SERVICE BULLETIN

14-08-35

MK4 B, C, F & T Series Tractors.
B Series B60-4TRAC, B250-4TRAC, C50, C60, C80, F60-4TRAC, F250-4TRAC, T50, T60 & T80.

A potential reverse pedal clash when using 36 HGM Deck. XRD Decks are unaffected. Problem exists on models produced between January and middle of May 2014.

The Reverse Pedal

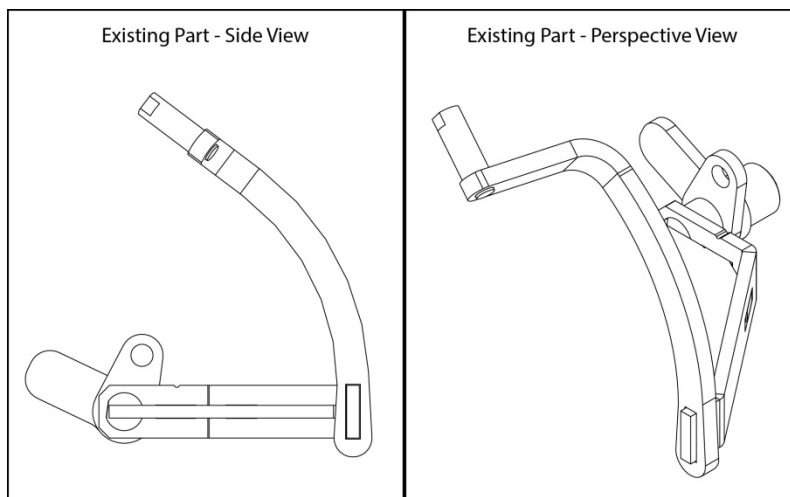
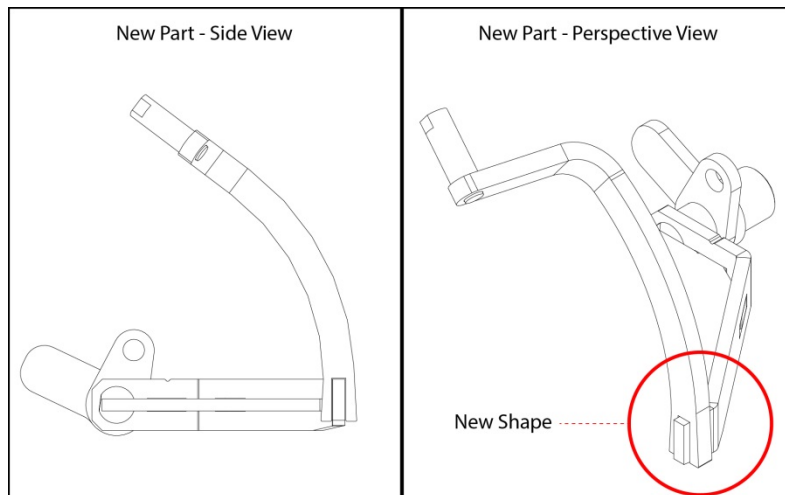
A potential problem has been identified with the reverse foot pedal and 36 HGM drive pulley safety guard. When the deck lift mechanism is operated the two parts will clash at level 7. This issue will prevent travel beyond level 7 to level 9. It could also cause damage to the deck and reverse pedal.

A modified pedal assembly has been produced. The new part avoids contact with the deck. This part can be swapped with the existing assembly with minimal rework.

New Part Name	Part Number	Comment
Reverse Pedal Assembly	329650200	Part number unchanged (revised issue)
